COMMUNICATION MATRIX

Project Number: 2020104385

Project Name: Inspiring Kids SUP, RUE, FLC, OAC, SEPA

Project #2020104385 Inspiring Kids

EXHIBIT 1 - SITE MAP

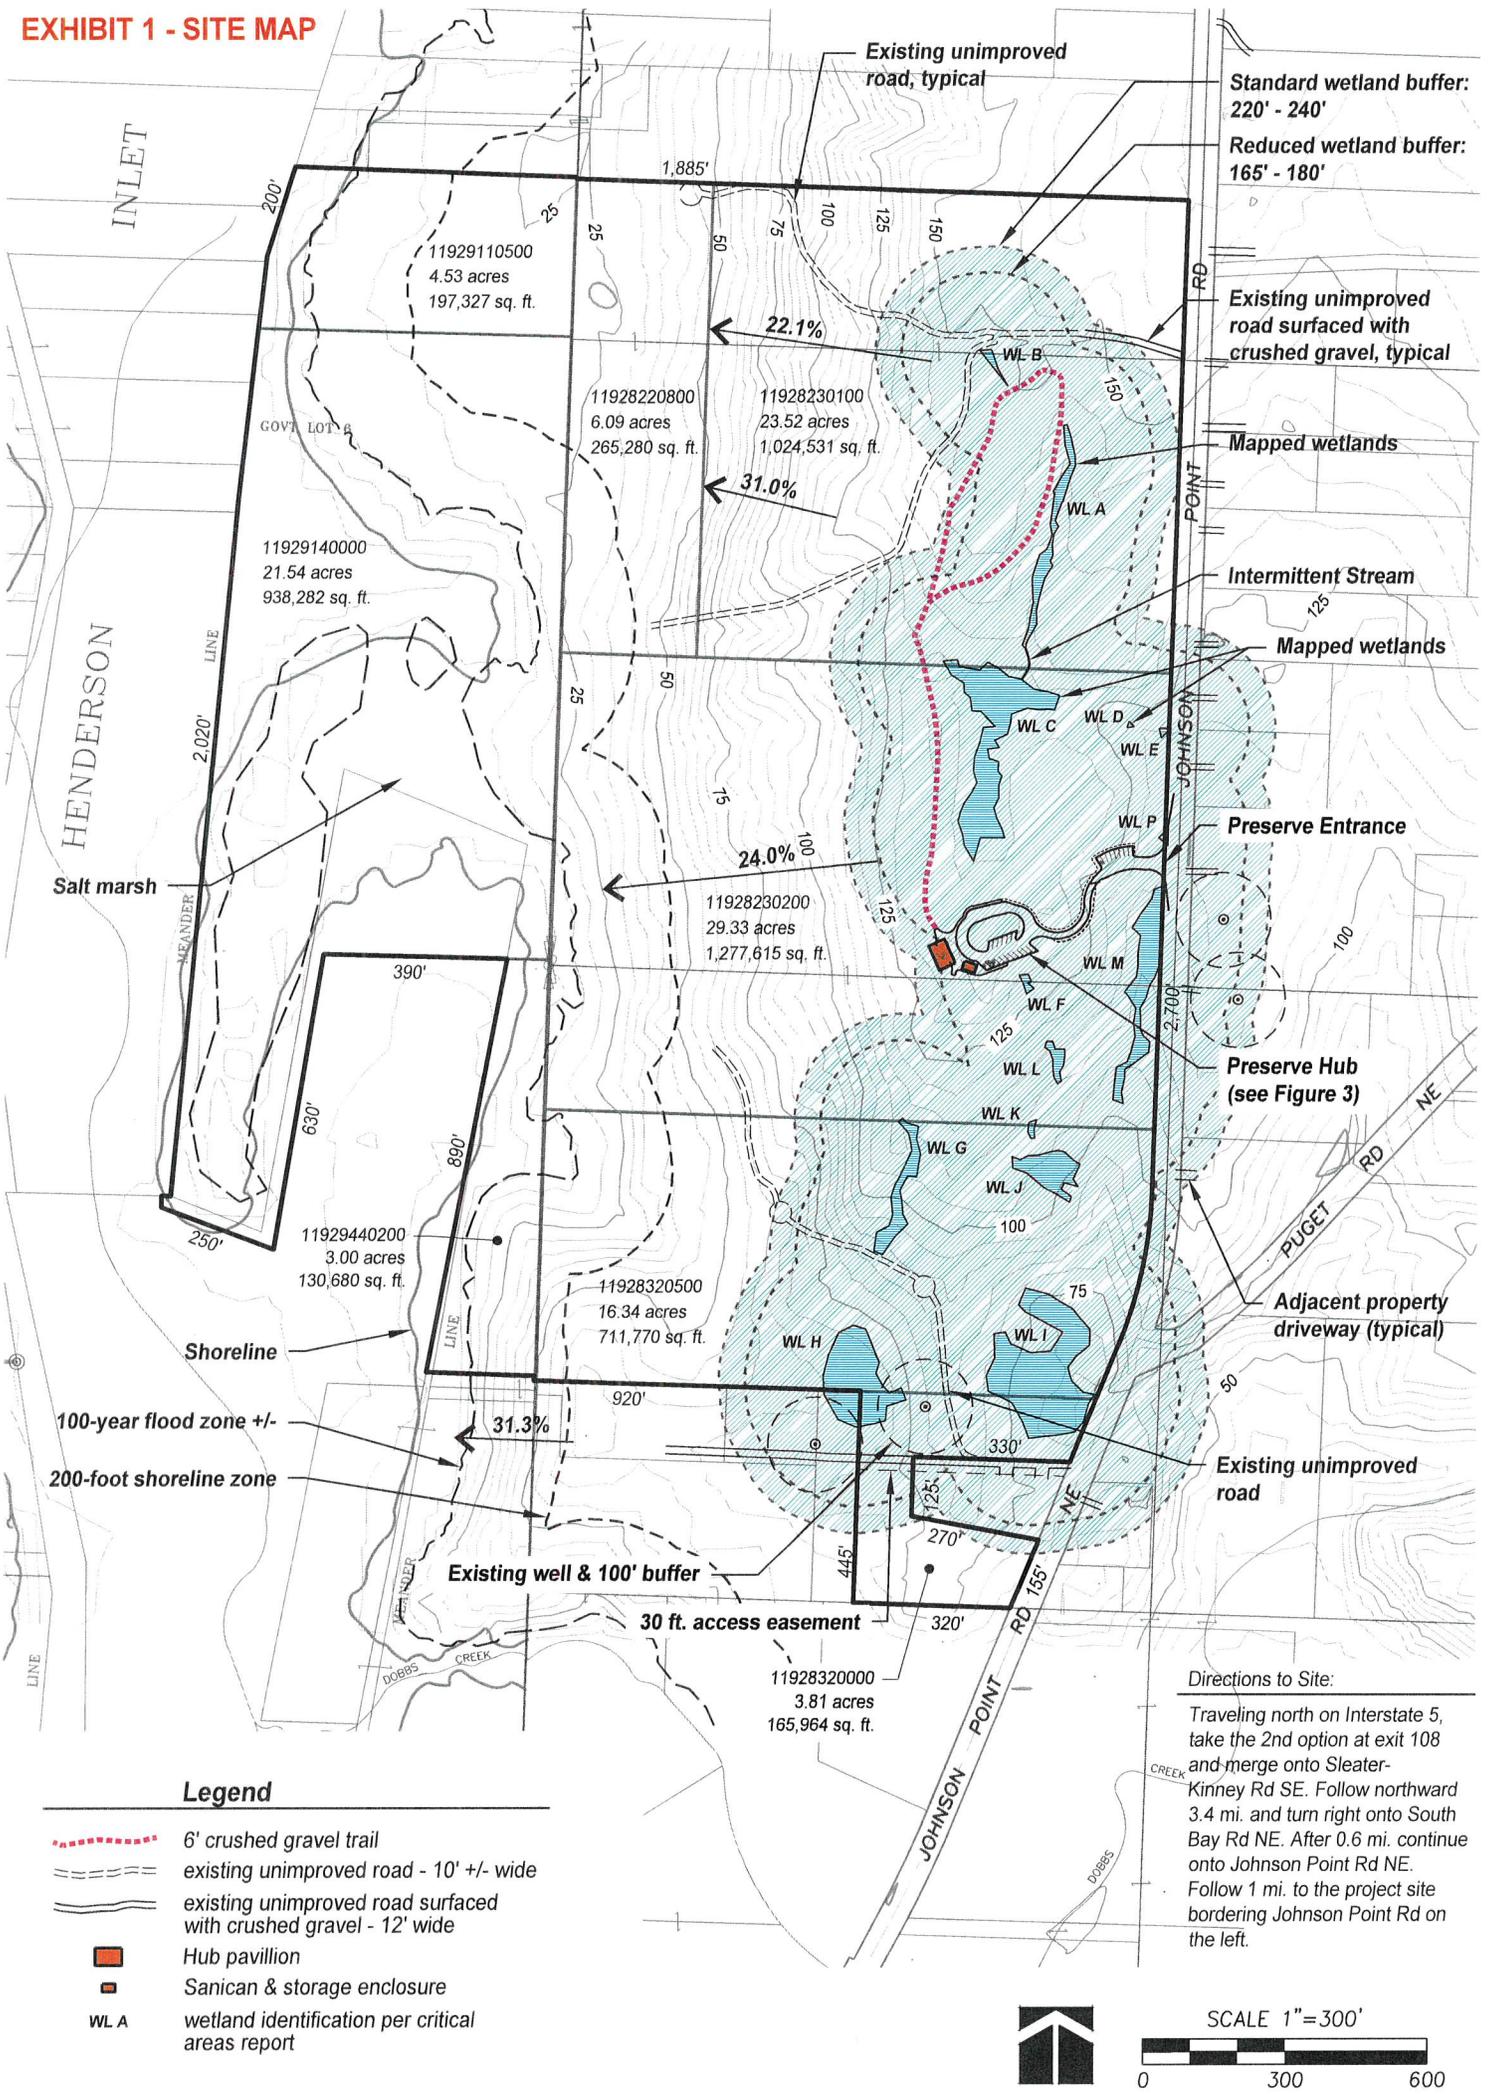
The location chosen for the access drive minimizes wetland impacts by crossing between two wetlands. Due to the required grading activities, direct wetland impacts are unavoidable. The proposed impacts will occur to a small, isolated Category IV wetland, Wetland P, and a small portion of Wetland M (See Exhibit 1 for wetland locations). There is no other feasible location for the access that could avoid wetland impacts while achieving the necessary dimensions and sight lines required for ingress/egress of buses. The chosen location avoids bisecting Wetland M, which could otherwise lead to unanticipated hydrology impacts. Buffer impacts have been minimized by removing the proposed well, septic field, bird blind, viewing platforms, and the shed at the northern entrance.
